Clinton Power Station

Clinton Power Station, Unit 1
Facility Operating License No. NPF-62
NRC Docket No. 50-461

Subject: Request for License Amendment for Extended Power Uprate Operation

Figure 3.1.7-1 (page 1 of 1)
Weight Percent Sodium Pentaborate Solution
Concentration/Net Tank Volume Requirements

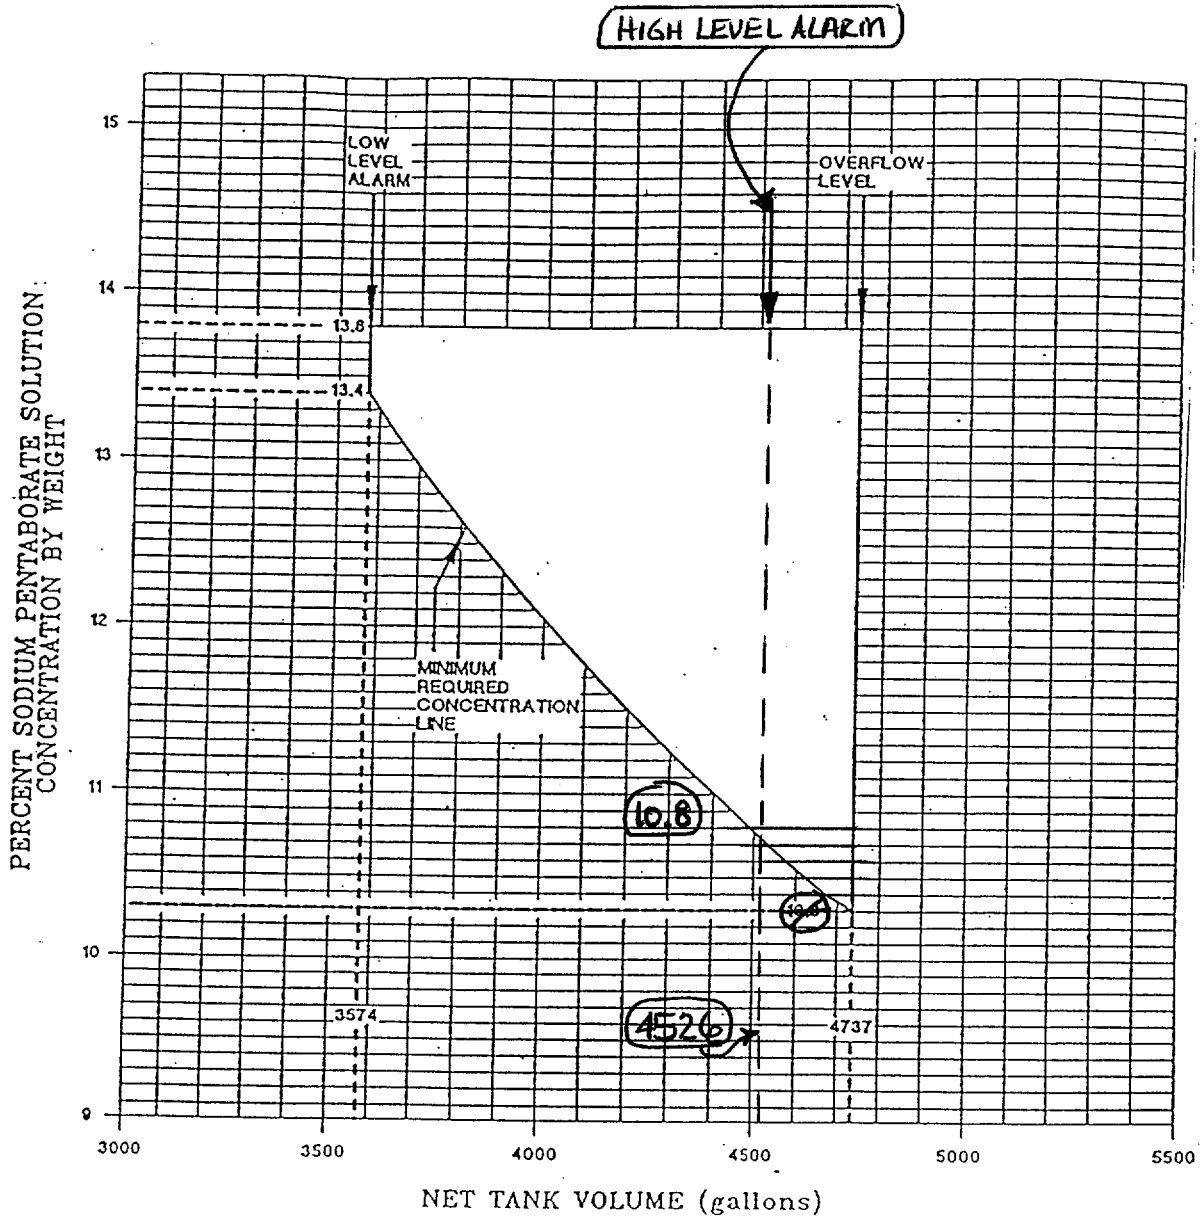
The proposed changes to TS Section 3.1.7, Figure 3.1.7-1 revise the SLC System concentration requirements. The Figure has been revised from a 10.3% to a 10.8% minimum allowable concentration.

The proposed changes to TS Section 3.1.7, Figure 3.1.7-1 revise the SLC System weight percent concentration versus volume requirements. The minimum allowable concentration as shown in the Figure has been revised from a 10.3% to a 10.8%. Replacement of the sodium pentaborate figure is consistent with the ATWS analysis in Section 9.3.1. Specific details supporting these changes are discussed in Section 6.5, "Standby Liquid Control System," of Attachment E.

TS Section 3.1.7, Figure 3.1.7-1 is revised to reflect a minimum SLC System weight percent concentration requirement from 10.3% to 10.8%.

Figure 3.4.1-1 (page 1 of 1)
Thermal Power/Core Flow Stability Regions

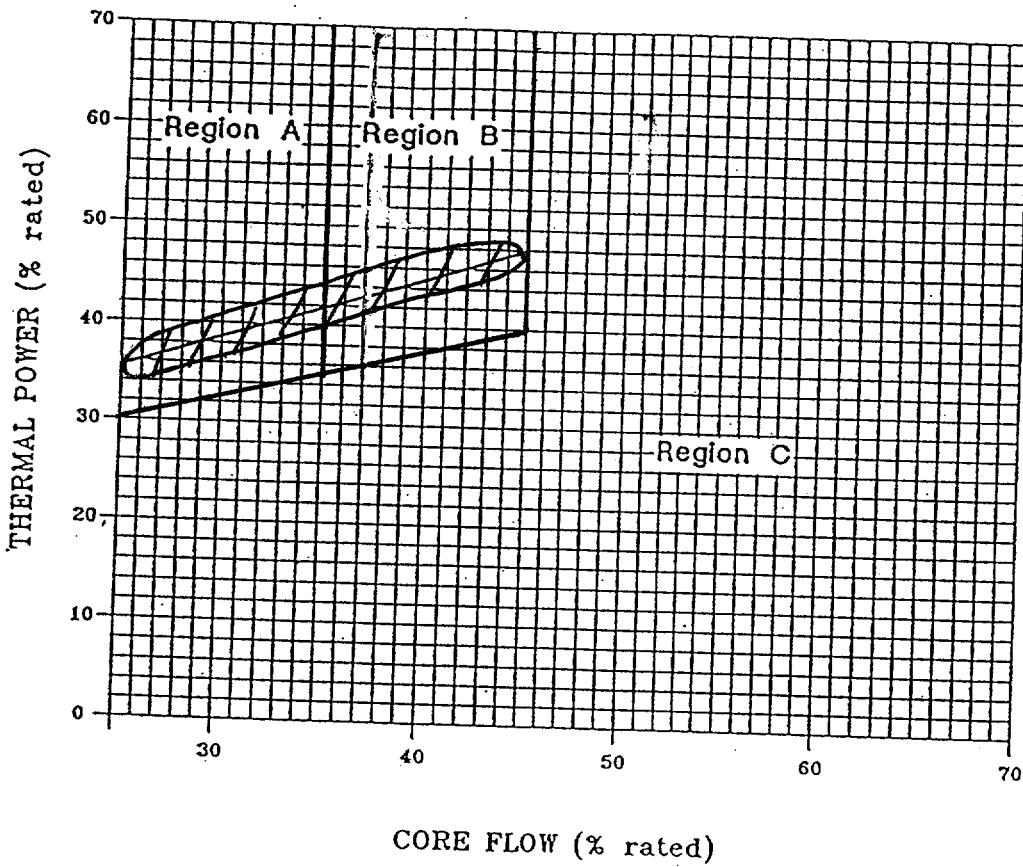
The proposed changes to the TS Limiting Condition for Operation (LCO), Required Action, and Figure 3.4.1-1 of TS Section 3.4.1 revise the percent RTP and corresponding operating region at which recirculation loops (i.e., single or both) shall be in operation. The percent RTP for the TS LCO has been revised from $\leq 70\%$ RTP to $\leq 58\%$ RTP. Similarly, the percent thermal power axis on Figure 3.4.1-1 has been re-scaled corresponding to the percent increase in power. The new percent RTP and stability limits are required to maintain the existing thermal power level under power uprate conditions.

The proposed changes to the LCO, Required Action, and Figure 3.4.1-1 of TS Section 3.4.1 revise the percent RTP and corresponding operating region at which recirculation loops (single or both) shall be in operation. The percent RTP for the LCO has been revised from $\leq 70\%$ RTP to $\leq 58\%$ RTP. Similarly, the percent thermal power axis on Figure 3.4.1-1 has been re-scaled corresponding to the percent increase in power. The new percent RTP and stability limits are required to maintain the existing thermal power level. For EPU, the thermal power has been reduced corresponding to the ratio of the power increase (i.e., 2894/3473). Specific details supporting these changes are discussed in Section 3.4, “Reactor Recirculation System,” of Attachment E.

TS LCO 3.4.1 is revised to state "THERMAL POWER \leq 58% RTP." Required Action E.1 is revised to state "Reduce THERMAL POWER to \leq 58% RTP." The RTPs have been revised from \leq 70% RTP to \leq 58% RTP. Condition E is revised to state "THERMAL POWER $>$ 58% RTP during single recirculation loop operation." The RTP has been revised from $>$ 70% RTP to $>$ 58% RTP. TS Figure 3.4.1-1 is revised to reflect the revised limits pertaining to the re-scaling of the thermal power axis.
